ALERT SERVICE BULLETIN

407-23-130

Revision A, 27 March 2023

SUBJECT: PILOT CYCLIC STICK ASSEMBLY 206-001-344-105/-109/-115, INSPECTION AND REPAIR OF.

Figure 1 – Pilot Cyclic Stick Assembly – 10X Magnifying Glass Inspection Area

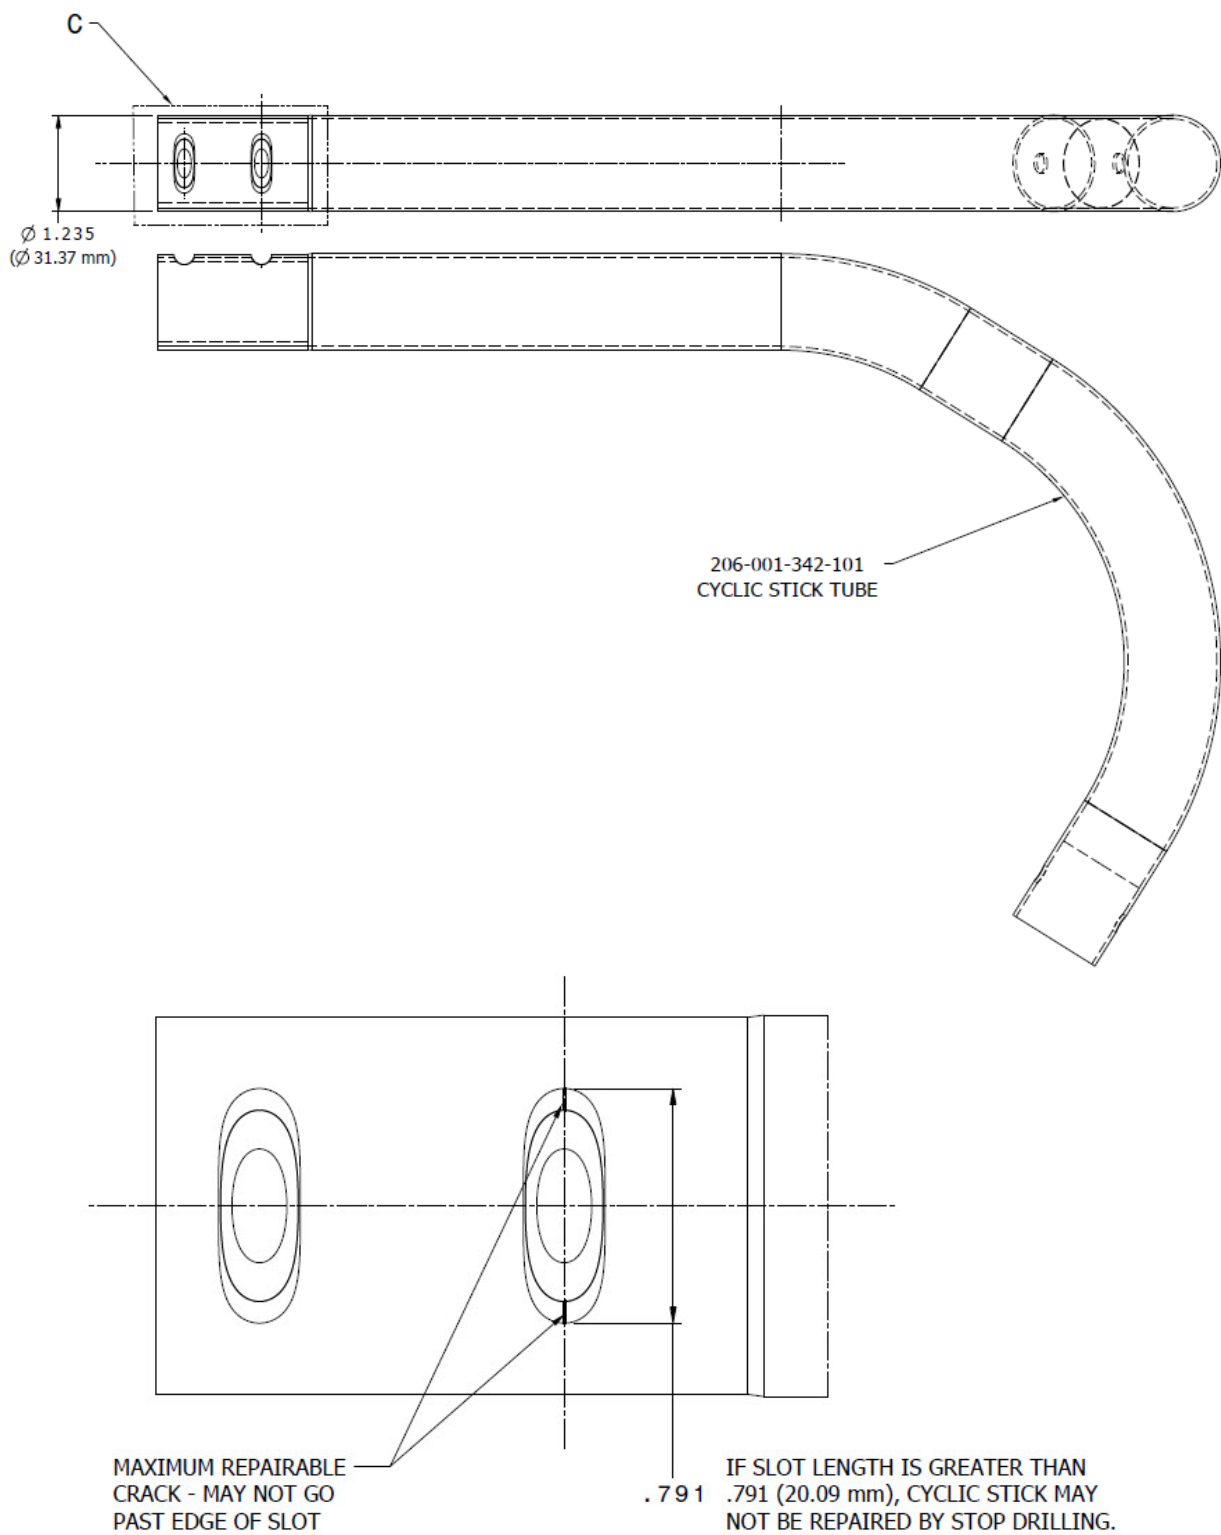
PART I of this bulletin mandates a 10X magnifying glass inspection of the lower four inches of the cyclic stick tube assembly (1, Figure 1).

Clean the lower 4.0 inches (101.6 mm) of the removed cyclic stick assembly with cleaning compound (C-318) before inspection (1, Figure 1).

1. Prepare the helicopter for maintenance.
2. Remove the pilot cyclic control stick ([DMC-407-A-67-12-03-00A-520A-A](#)).
3. Clean the lower 4.0 inches (101.6 mm) of the removed cyclic stick assembly (1, Figure 1) with cleaning compound (C-318) before inspection.
4. Inspect the lower 4.0 inches (101.6 mm) of the cyclic stick tube using a 10X magnifying glass. Pay particular attention to the stop-drilled repair area.

Figure 2- Typical Crack Location and Maximum Repairable Crack Length

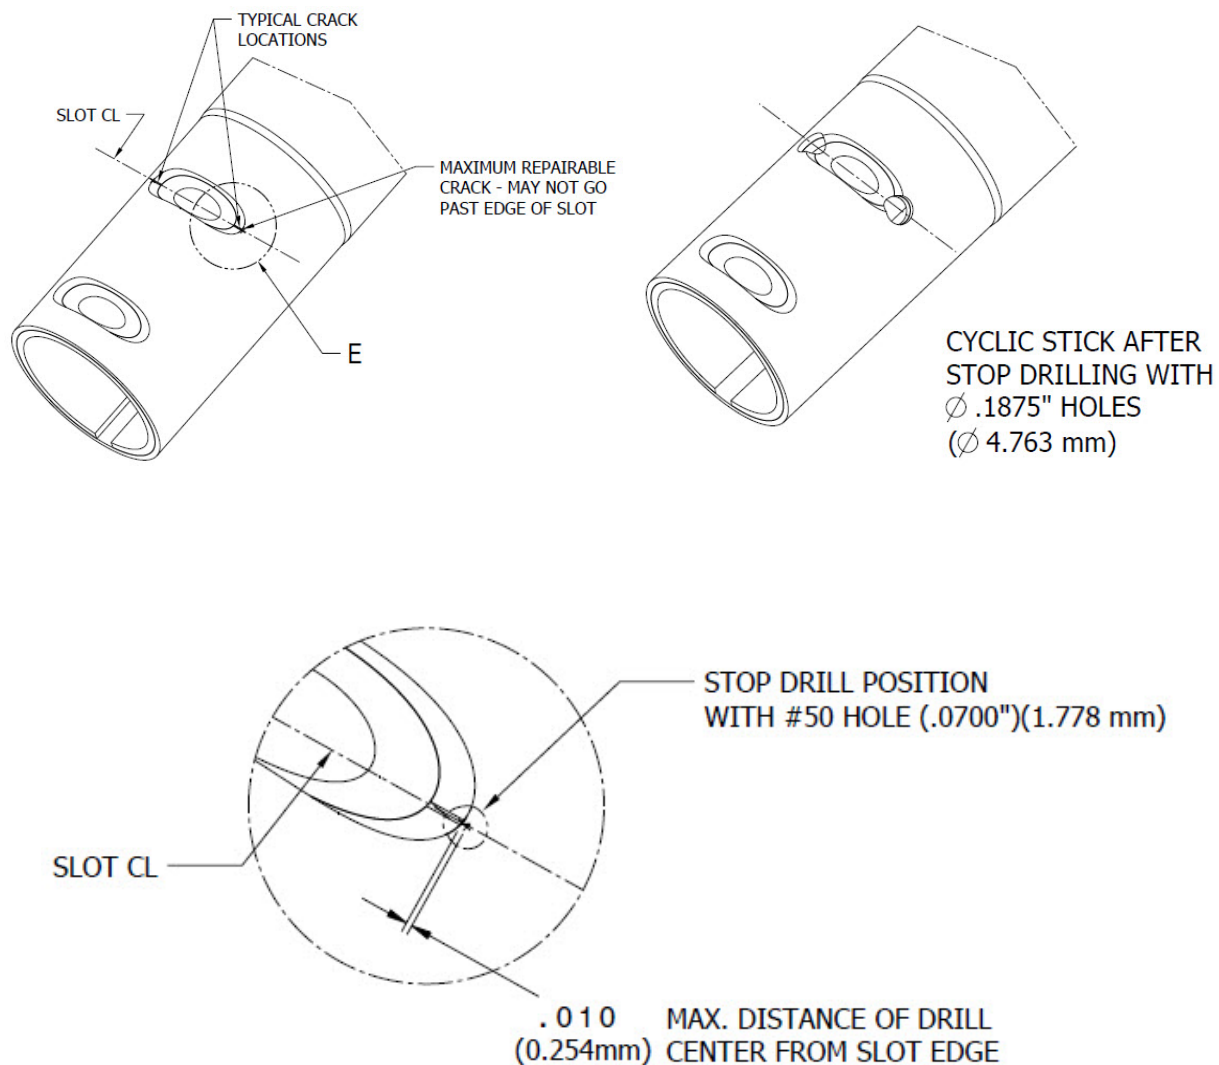
PART II of this bulletin provides a repair for cracked 206-001-342-101 cyclic stick tube assemblies consisting of a stop drill procedure. This repair can only be performed for cracks initiating in the upper slot on the lower part of the stick tube. The maximum repairable crack length is shown in Figure 2 of this bulletin.

- i. The following inspection criteria apply to a cracked cyclic tube stick assembly eligible for the accomplishment of **PART II**:
 1. Cracks that extend beyond the edges of the slot are not permitted (Figure 2).
 2. Cracked slot lengths longer than 0.791 inch (20.09 mm) are not permitted.
 - ii. If the crack length in the cyclic stick assembly exceeds the criteria of step 2.d.(i), the cyclic stick tube assembly will be considered unserviceable and must be replaced by a serviceable cyclic stick tube assembly meeting the intent of this bulletin prior to next flight.
3. Customers finding a cracked cyclic stick tube assembly must send an email to Bell Product Support Engineering at productsupport@bellflight.com with the following information.
 - a. Subject Line: Helicopter model, serial number and ASB number.

The maximum repairable crack length that can be stop drilled cannot be beyond the outside edge of the slot (Figure 2). The pilot hole for the stop drill must be in the full thickness of the tube, centered along the centerline of the slot and no further than 0.010 inch (.25 mm) from the edge of the slot (Figure 3, Sheet 1 of 2).

Figure 3 (Sheet 1 of 2) – Pilot Hole Location for Stop Drill

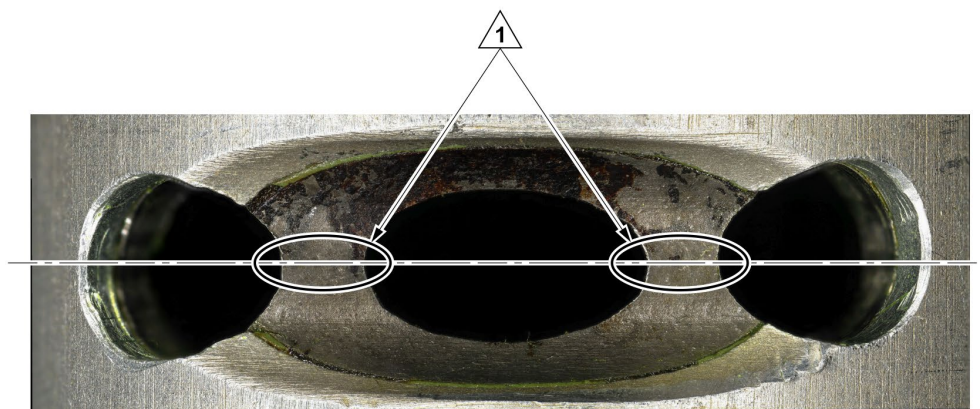
- a. Use an automatic center punch to mark the edge of the slot (Figure 3, Sheet 1 of 2).

Figure 3 (Sheet 2 of 2) – Stop-Drilled Holes and Inner Sleeve

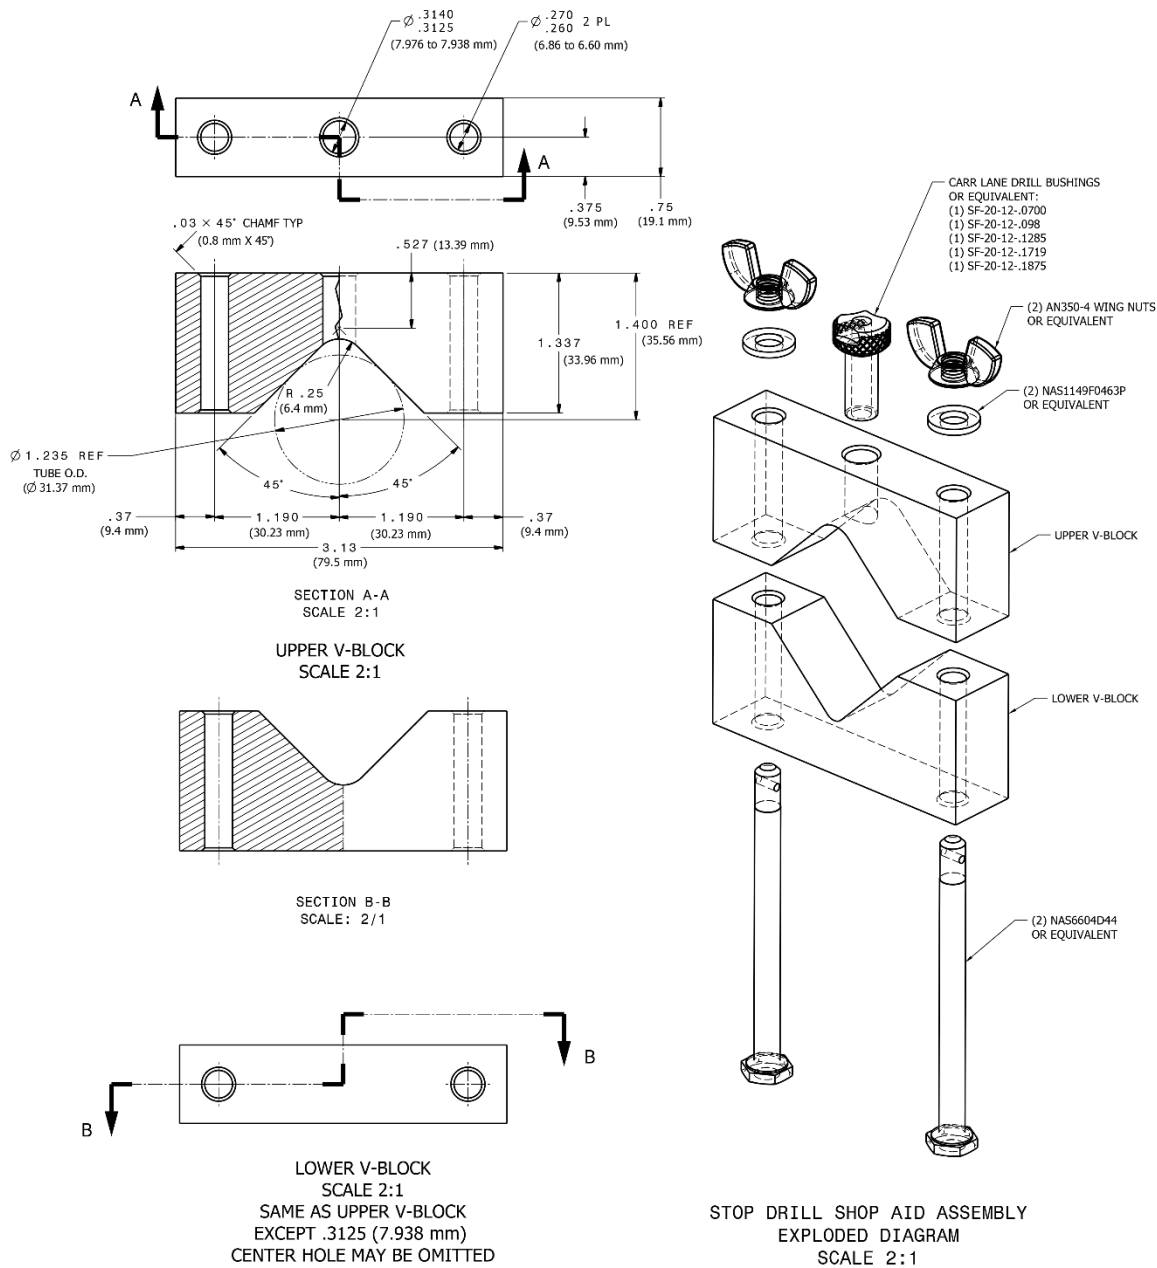
Cracks in the circled areas of the inner sleeve inboard of the stop-drilled holes as shown in Figure 3 (Sheet 2 of 2) are not cause for rejection.

Cracks in the circled areas of the inner sleeve inboard of the stop-drilled holes are not cause for rejection.

Figure 5 – Cyclic Stick Tube with Workaid Installed

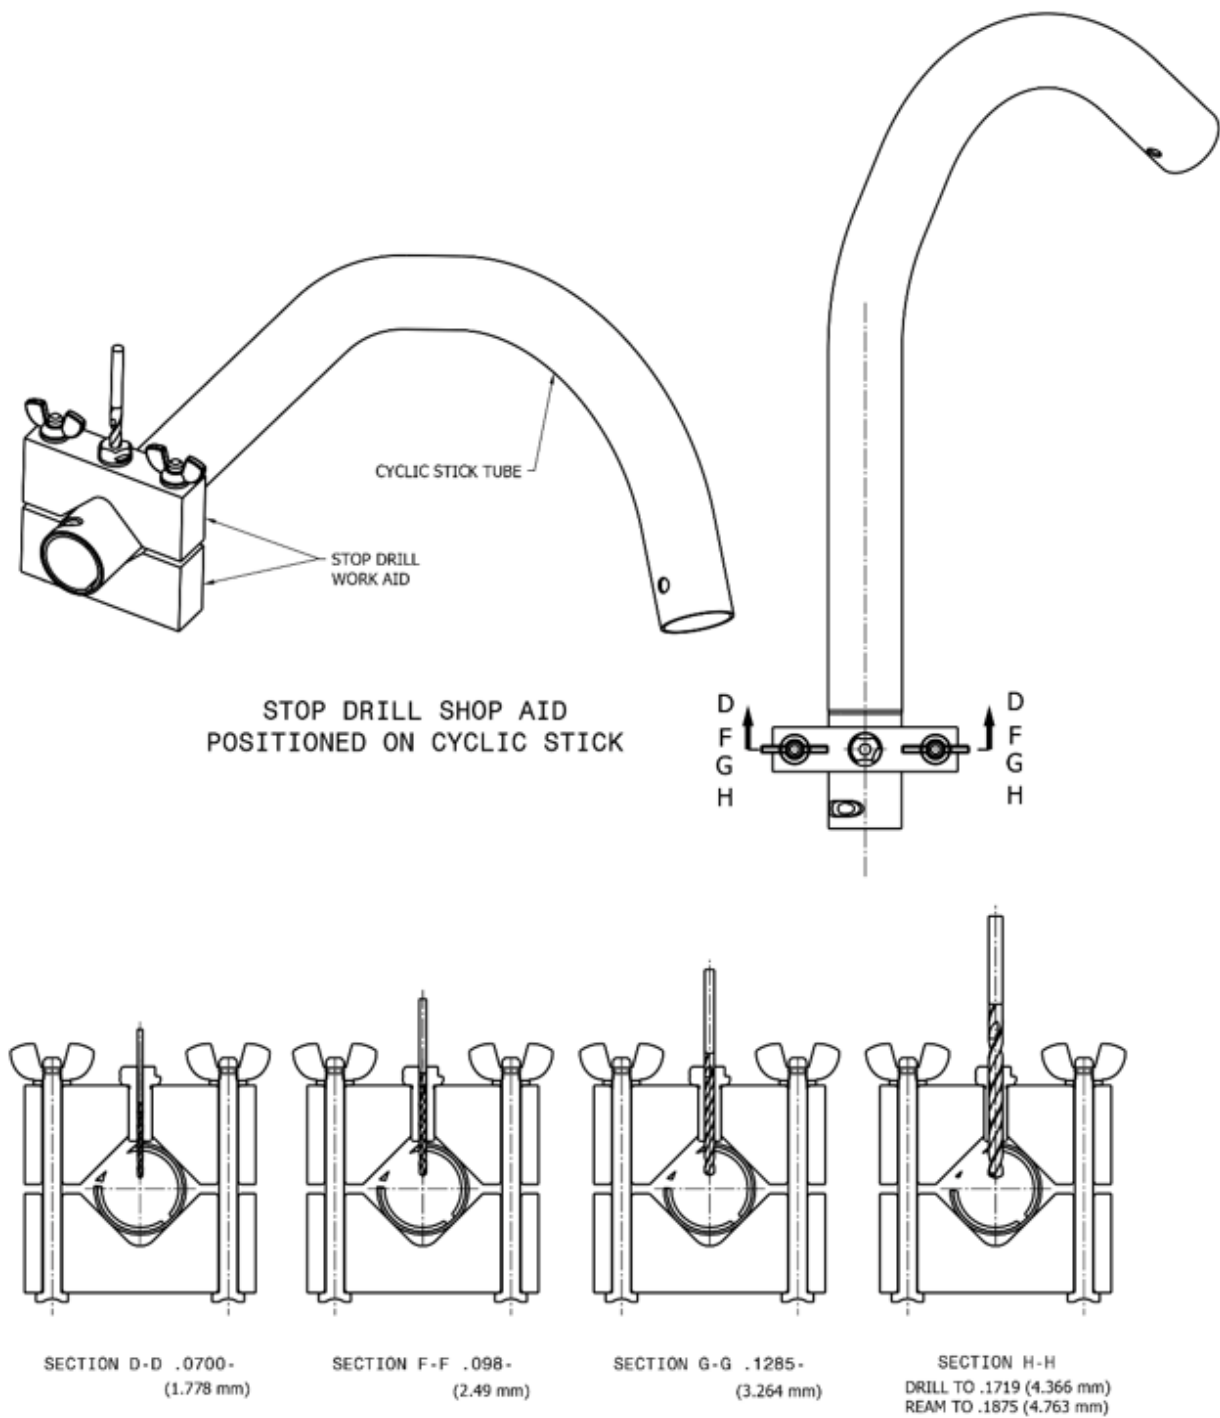
Revision A of this bulletin requires customers to contact Bell Product Support when finding a cracked cyclic stick tube assembly. Figures with drill bushings revised to allow a final ream of .1875-inch (4.763mm).

- b. Locally manufacture a workaid (Figure 4) and procure drill bushings or have the cyclic stick tube stop-drilled in a milling machine.
- c. Install the drill guide on the cyclic stick tube (Figure 5) and line up with the center punch mark using the smallest drill bushing.
- d. Secure the drill guide by tightening the nuts only enough to stop the drill guide from moving. Confirm that the drill bushing hole is exactly in line with the center punch mark. Do not over-tighten nuts and bolts to avoid damaging the cyclic stick tube.
- e. Drill a pilot hole using the smallest drill guide. Use a drill stop to limit the drilling depth to avoid damaging the opposite side of the tube.

- f. Increase the stop drill hole diameter until a final ream of 0.1875 inch (4.76 mm) is achieved. Deburr holes.
- g. Once the stop drill procedure is completed, carry out a fluorescent penetrant inspection (FPI) of the repaired area to ensure the crack is removed and there are no cracks in the stop drill bore. (BHT-ALL-SPM, Chapter 6).
- h. Thoroughly clean the cyclic stick tube with water and mild detergent (C-318) to completely remove residual penetrant and developer.
- i. Dry the cyclic stick assembly completely.
- j. Touch up the repaired area with epoxy polyamide primer (C-204). Refinish the repair as required to match the original finish with polyurethane coating (C-245) (BHT-ALL-SPM, Chapter 4).
